SUBJECT: **RFQ FOR DESIGN-BUILD SVCS FOR HORIZONTAL/CIVIL ENGINEERING PROJECTS**

Recommend approval of Change Order #1 to J. B. Coxwell Contracting, Inc., in the amount of $285,361.33, to address the increased construction costs due to design modifications required to address unknown utility conflicts and will provide 100% design, permitting and construction for the modifications. This incorporates the attached, scope and fee summary, Exhibit "Y-2", for a revised guaranteed maximum price of $622,939.51, which includes a contingency of $20,000.00 and allows for a project completion of 120 days for design and permitting and an additional 90 days from the notice to proceed for construction for an additional total of 210 days. Total annual expenditure amount is currently at $30,000,000.00; total amount spent to date is $19,427,438.05.

**SUBJECT:** CDB-0006-16 – Design-Build Services - Horizontal & Civil Engineering – Ocean Street Drainage Improvements AMENDMENT 23B

**Re: Scope of Services and Fee Proposal for Ocean Street Drainage Improvements (revised design) 100% Design, Permitting and Construction Services – Price Revision 4**

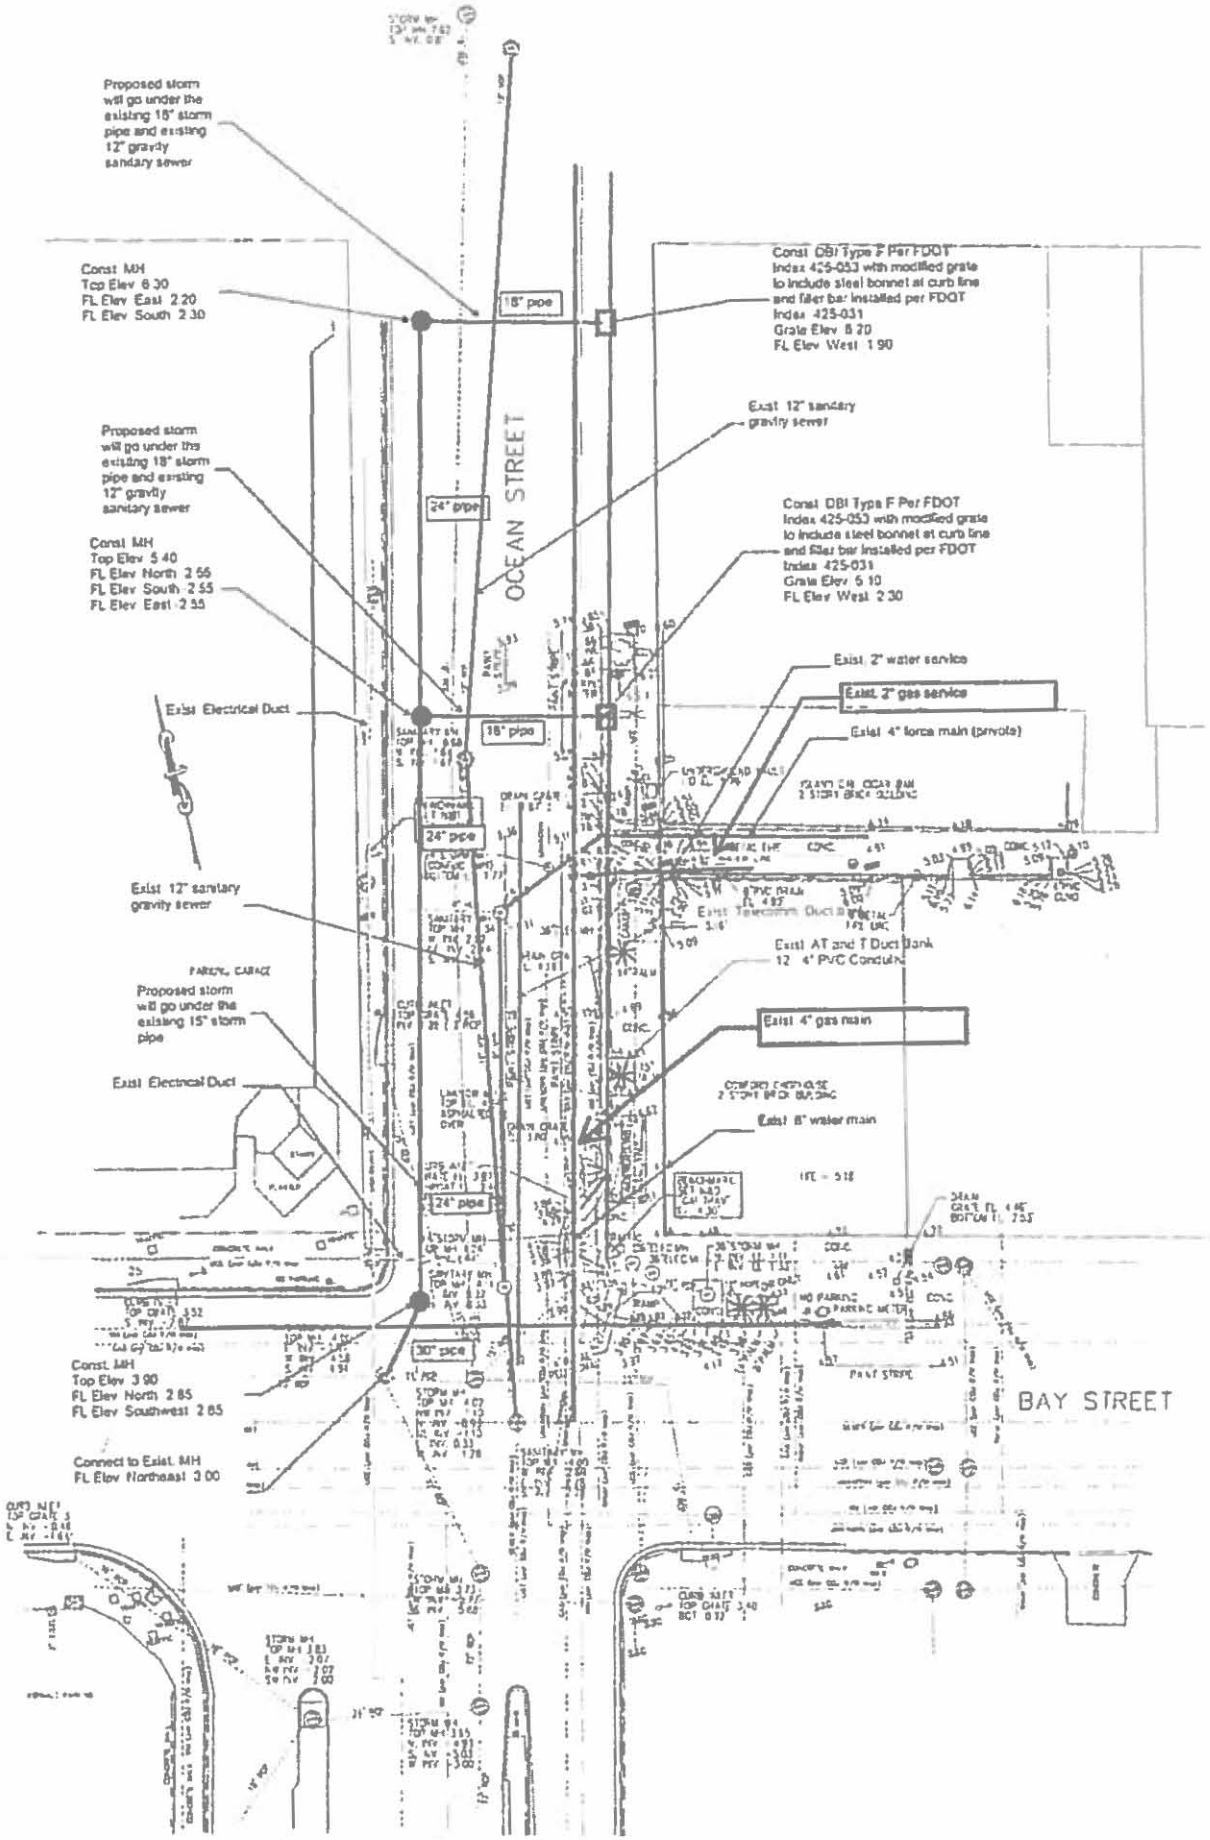
This project was previously awarded to JBCCI for the lump sum amount of Three Hundred Thirty-Seven Thousand Five Hundred Seventy-Eight Dollars and Eighteen Cents ($337,578.18) under contract 6533-54, amendment 23A. Since the design has been modified on this project to increase the scope of the services provided, JBCCI submits to you the revised lump sum amount for 100% design, permitting and construction fees of Five Hundred Forty-Six Thousand Three Hundred Seventy Dollars and Thirteen Cents ($546,370.13) which includes a project contingency of $20,000.00. The project contingency is for project elements which have not been fully designed and permitted, and which may increase in quantity or cost during the final design phase or during construction. The project contingency is for the Design-Builder's benefit and not for changed field conditions, unknown field conditions or added scope of work.

- Estimate is based on GAI's updated design and engineering fees as shown in the proposal dated 1-23-20, added fees (verbal), GAI's revised drainage sketch attached. All notes, exclusions, and clarifications contained in the GAI proposal apply to the JBCCI proposal.

Proposed storm will go under the existing 18" storm pipe and existing 12" gravity sanitary sewer
Const MH
Top Elev 6 30
FL Elev East 2 20
FL Elev South 2 30
18" pipe
Const DBI Type F Per FDOT Index 425-053 with modified grate to include steel bonnet at curb line and filler bar installed per FDOT Index 425-031
Grate Elev 6 20
FL Elev West 1 90
Exist 12" sanitary gravity sewer
OCEAN STREET
Proposed storm will go under the existing 18" storm pipe and existing 12" gravity sanitary sewer
24" pipe
Const MH
Top Elev 5 40
FL Elev North 2 55
FL Elev South 2 55
FL Elev East 2 55
Const DBI Type F Per FDOT Index 425-053 with modified grate to include steel bonnet at curb line and filler bar installed per FDOT Index 425-031
Grate Elev 5 10
FL Elev West 2 30
Exist 2" water service
Exist 2" gas service
Exist Electrical Duct
18" pipe
Exist 4" force main (private)
24" pipe
Exist 12" sanitary gravity sewer
Exist AT and T Duct Bank

12 4" PVC Conduits
Proposed storm will go under the existing 15" storm pipe
Exist 4" gas main
Exist Electrical Duct
Exist 8" water main
24" pipe
30" pipe
Const MH
Top Elev 3 90
FL Elev North 2 85
FL Elev Southwest 2 85
Connect to Exist MH
FL Elev Northeast 3 00
BAY STREET
